Contested Case No. W1-103

**ARIZONA DEPARTMENT OF WATER
RESOURCES' NOTICE OF FILING
REPORT**

Review of SRP – Leonard Rice Subflow Depletion Demonstration Project Report (Nov. 1, 2019).

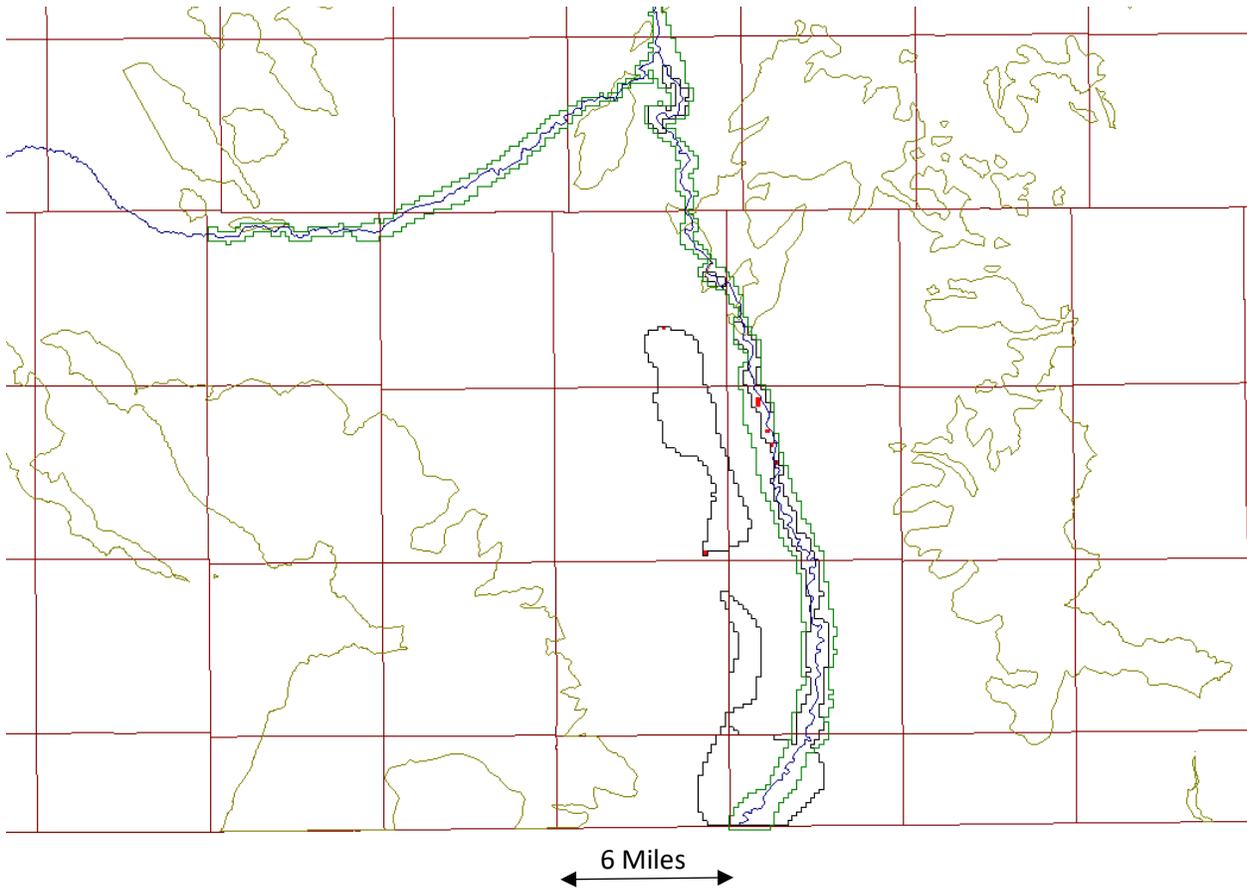
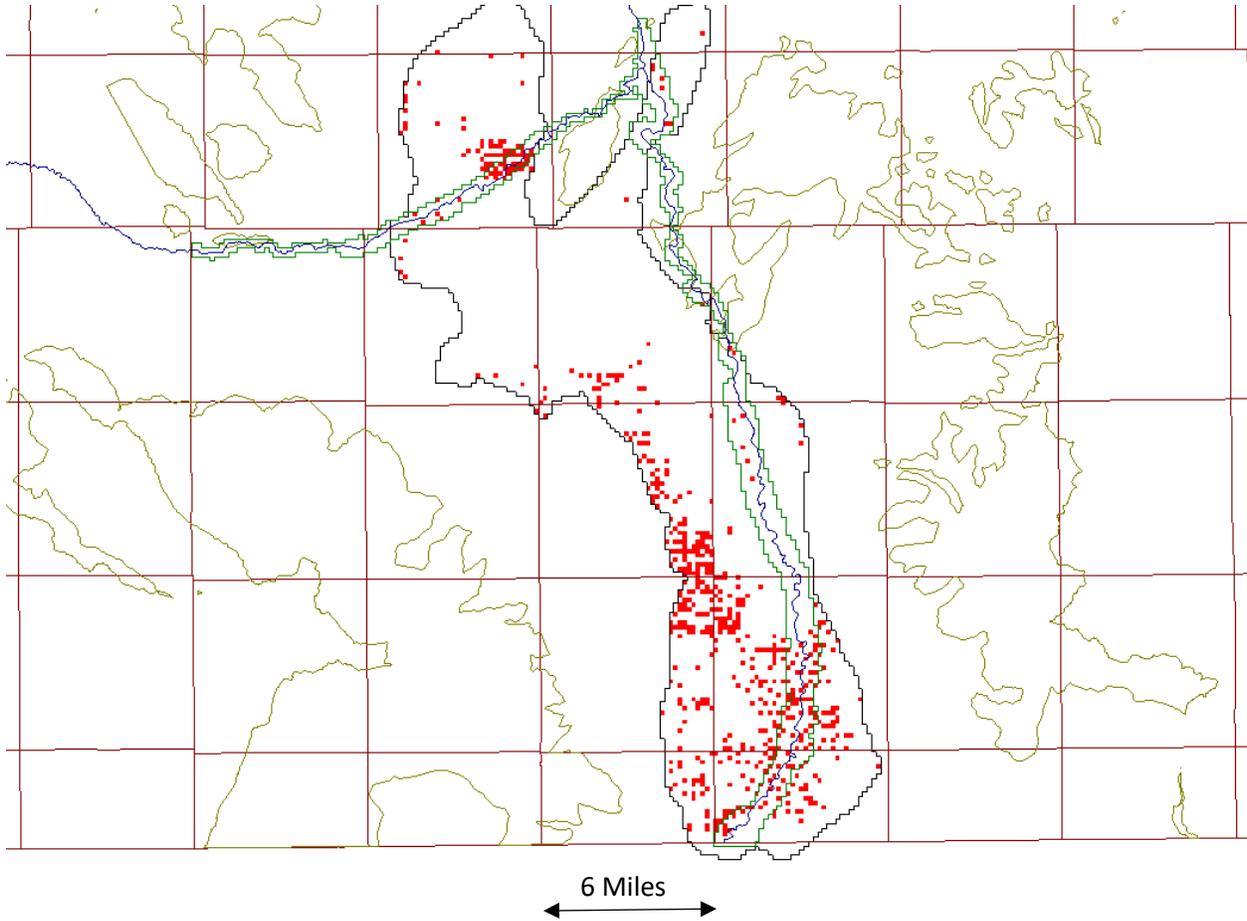
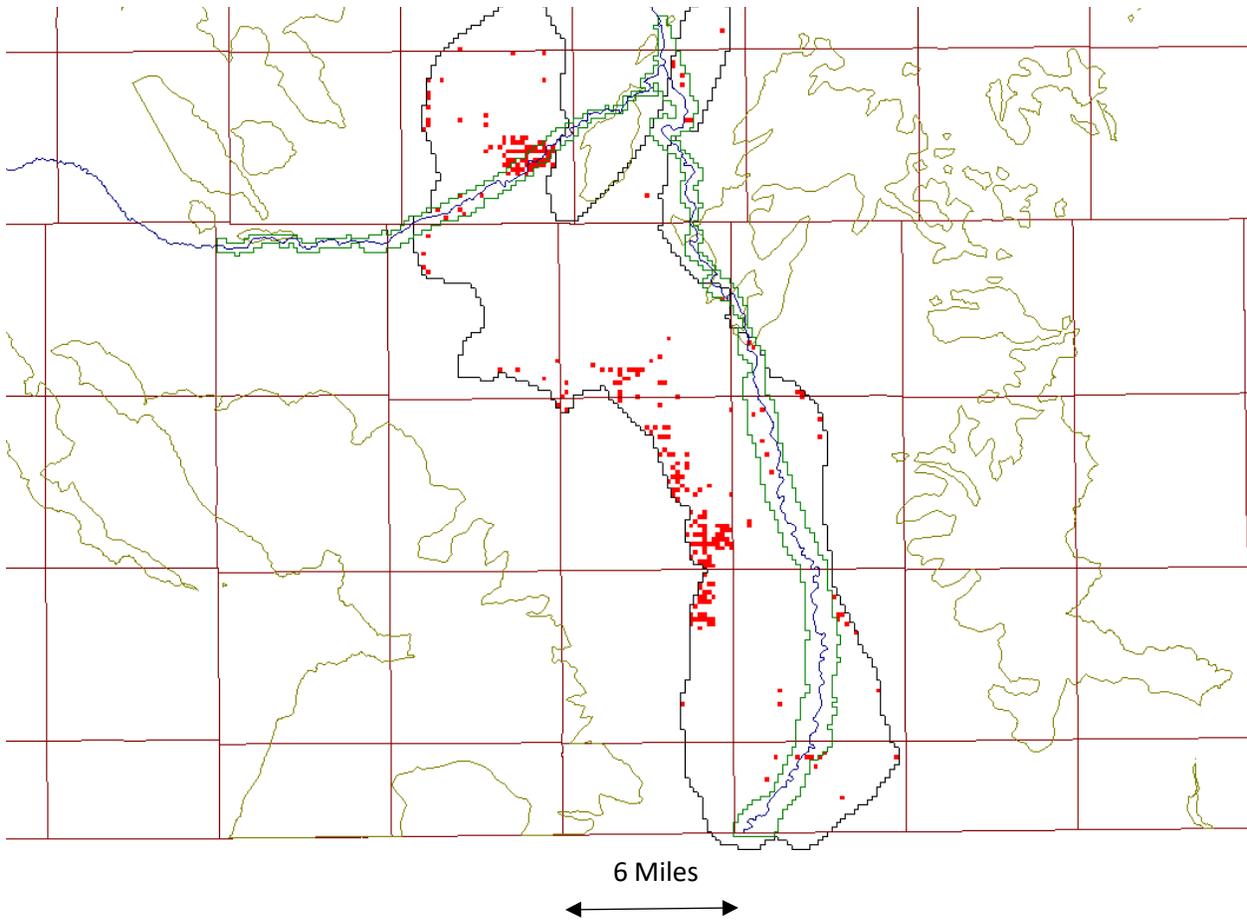
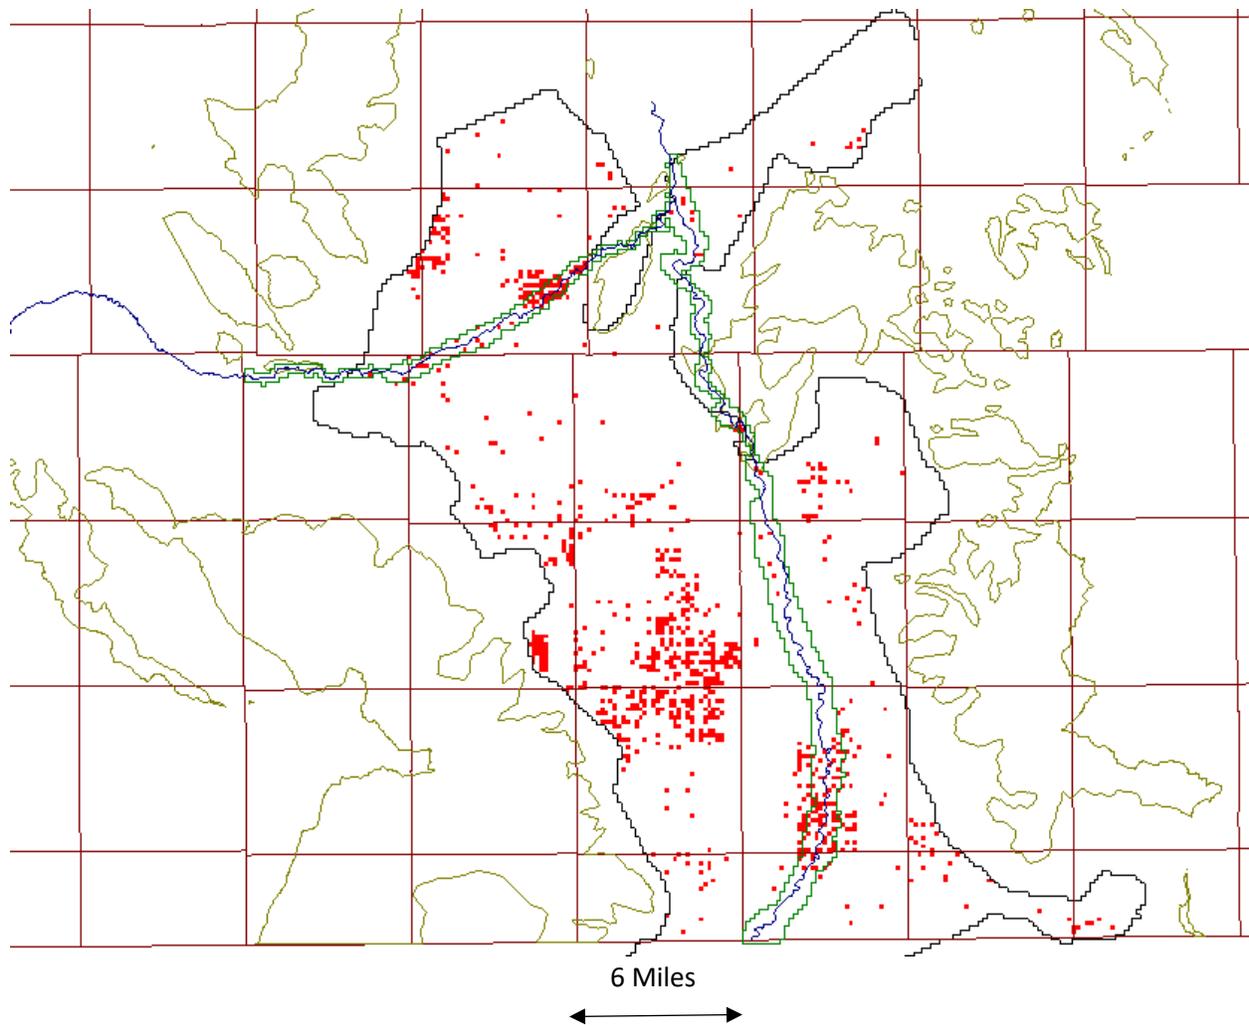
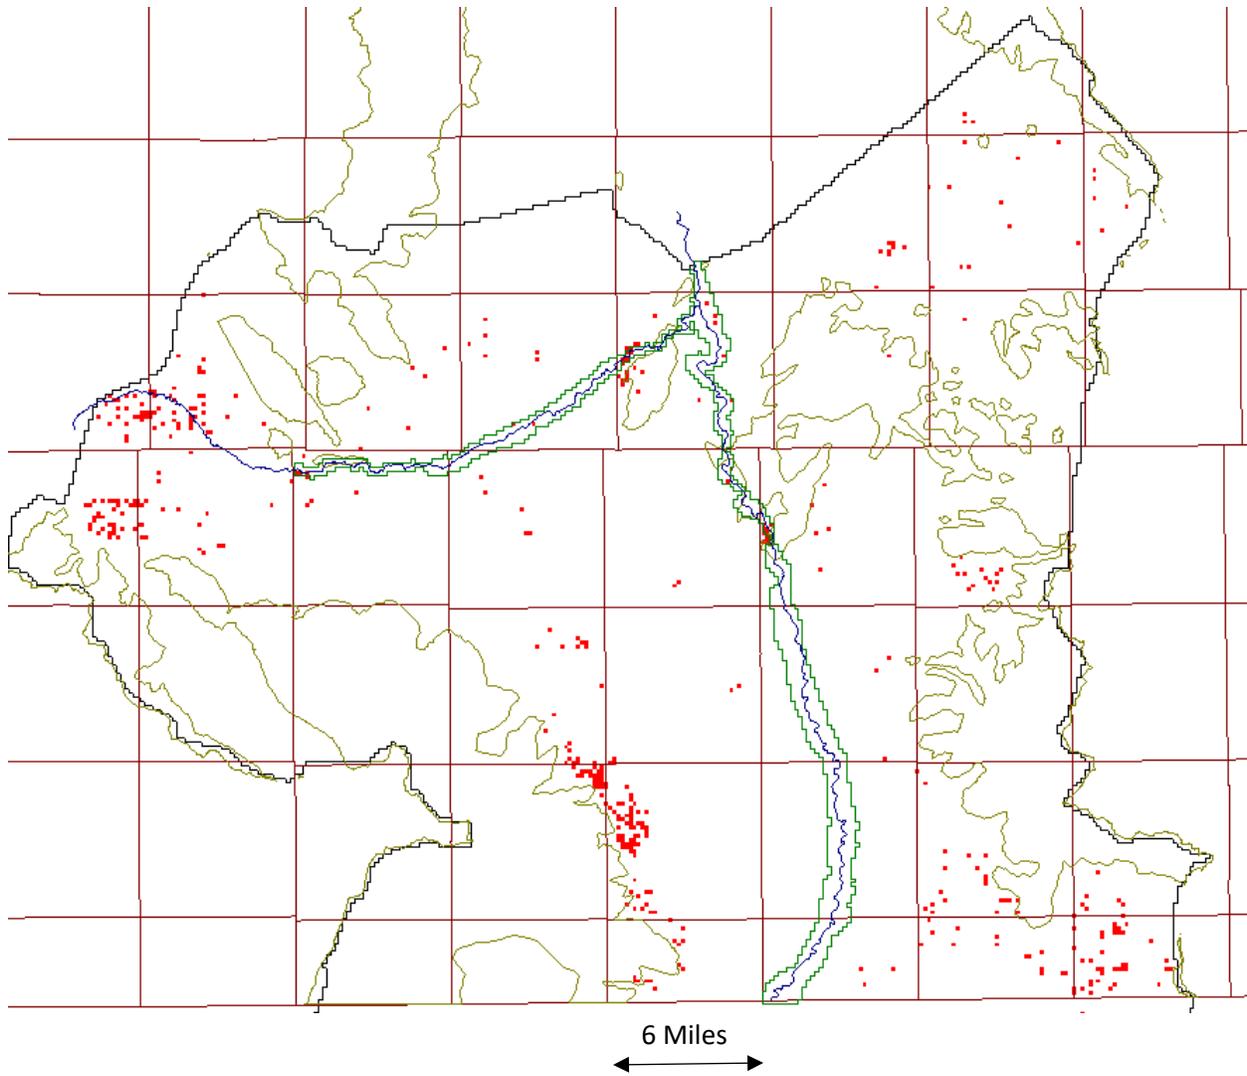
ADWR believes the examples presented in the LR SDDP report are generally non-representative of distances between the SFZ boundary and most wells located outside the SFZ in the Sierra Vista Sub-Watershed (see **Figures 1-5**). ADWR’s review of the 2006 USGS Sierra Vista Sub-watershed Groundwater Flow Model (the SVS model) indicates that the vast majority of pumping wells in the SVS model area are located substantially farther from the SFZ than 2,500 feet (see **Tables 1-4**). The consequence of most wells being located much farther away from the SFZ than the examples provided in the LR SDDP report were clearly shown in ADWR’s 2018 Initial Report on Subflow Depletion Testing (ADWR, 2018). The results reported in the 2018 ADWR report showed that there was

essentially no change in the volume of flow from the SFZ to the regional aquifer after 200 years of historic and projected future pumping by hundreds of wells (ADWR, 2018, Figures 5, 6, 7). ADWR believes the LR SDDP report examples are very non-representative of current and future subflow depletion conditions for the vast majority of wells located outside the SFZ in the SVS model area.

Figure 8: Diagram of Zone Budget Analysis for SFZ Depletion from Base SS Model (No Pumping) to Base SS Model (With Pumping)

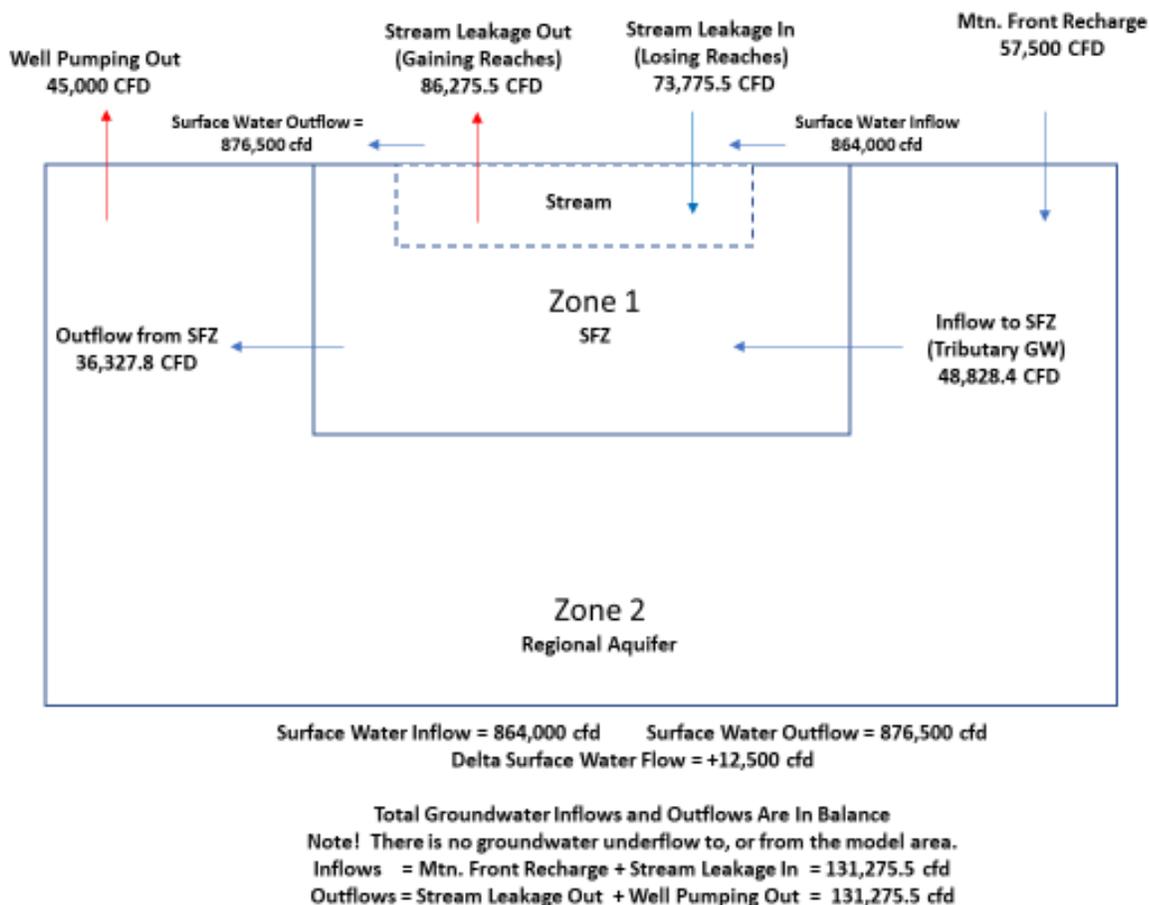
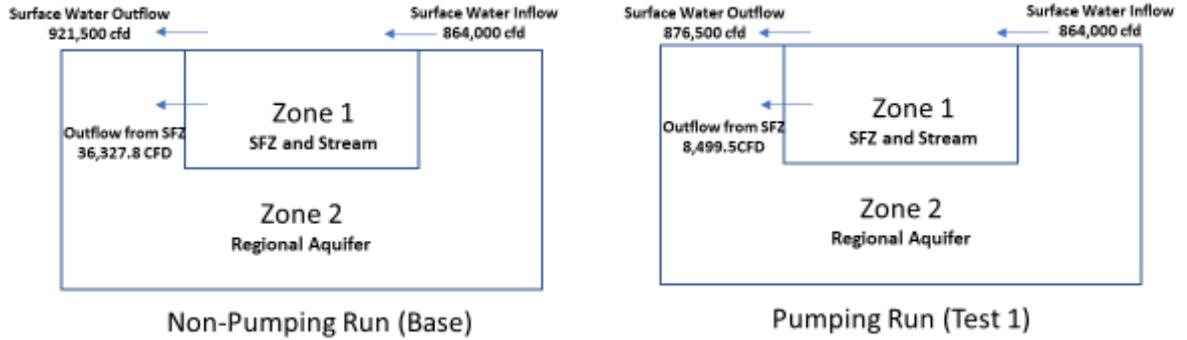
The Base Model described in the SRP Demonstration Project illustrates that even though the subflow zone is depleted by just 61% of the 45,000 cubic feet per day (cfd) pumping rate of a hypothetical well under steady state conditions, streamflow leaving the model is actually reduced by 45,000 cfd, 100% of the pumping rate. (See **Appendix A**, Figure 8). This confirms ADWR's conclusion from its December 2018 Initial Subflow Depletion Test Report:

The LR SDDP report model dataset files include Excel spreadsheets listing Zonebudget output for various model runs. The rates reported for Zone 1 on the line labeled “Stream Flow Out” on the IN portion of the budget listing are incorrect. The rates listed on that line are the rates reported by Zonebudget. However, the stream flow out should be 921,500 cubic feet day (CFD) for the Base SS model with no pumping, and 876,500 CFD for the Base SS model with pumping (**Figures 6 and 7**). As setup in the LR SDDP Zonebudget zone input file, the Zonebudget program calculates the “Stream Flow Out” component by summing the stream flow out for each stream reach (stream cell); for example multiplying 864,000 times the 14 stream cells in the 10x10 model equals 1.209E07 CFD and multiplying 864,000 times 126 stream cells in the 90x90 model equals 1.088E08 CFD, which are approximately equal to the “Stream Flow Out” values reported for the Base SS and Test1 SS models.

Although this budget item doesn’t actually enter into the flow process used by SRP/LR to calculate SFZ depletion (**Figure 8**), it should be corrected or deleted to avoid confusion.
